# TECHNICAL SERVICE BULLETIN

Technical Service Bulletin: 203-1287

Forest River is alerting you to an issue involving certain 2021 Catalina BCAT184BHS travel trailer Recreational Vehicles. Please see the information below, which describes the issue and provides you with details on the steps you should take to have your vehicle repaired.

# TECHNICAL SERVICE BULLETIN 203-1287 REMEDY INSTRUCTIONS

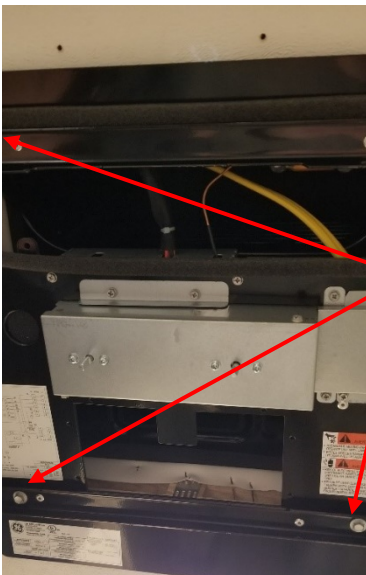
Locate the interior A/C shroud.

The "SMALL" grill will be on the rearward side (incorrect)

The "LARGE" grill will be on the forward side (incorrect)

Remove 8 screws around the parameter of the shroud.

Remove 2 Philips head screws that secure the shroud to the interior A/C chassis. One on each side of the "SMALL" opening.

Remove the four bolts that clamp the interior black A/C chassis to the exterior A/C.

Detach the interior chassis from all components, **ROTATE** 180 degrees and re-install using the same four bolts.

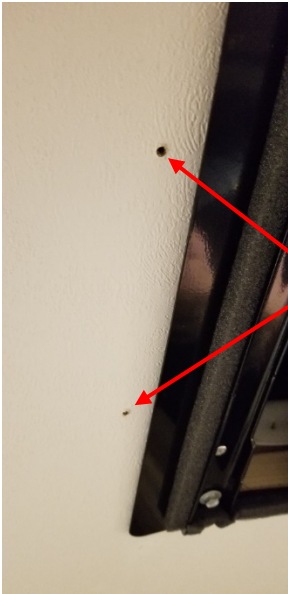
Re-install the air deflector as show in this photo. If there was not an air deflector installed, be sure to install one in this manor to isolate the air to flow appropriately across the cooling fins of the A/C.

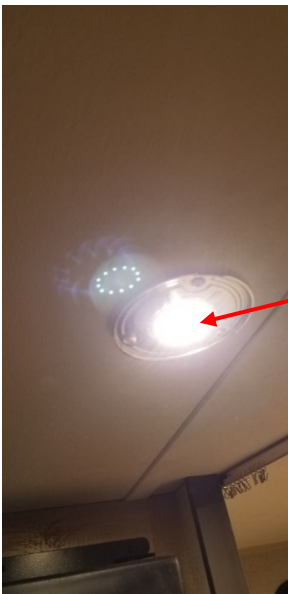
With the interior A/C chassis rotated, on the forward side, there is a potential for two screw holes to be left exposed. These will need to be filled and repaired so they are not visible.

With the interior A/C chassis rotated, on the rearward side, there is a potential for the ceiling light to interfere with the plastic A/C shroud. Move the ceiling light rearward just enough to miss the A/C shroud and still hide any holes it may leave.
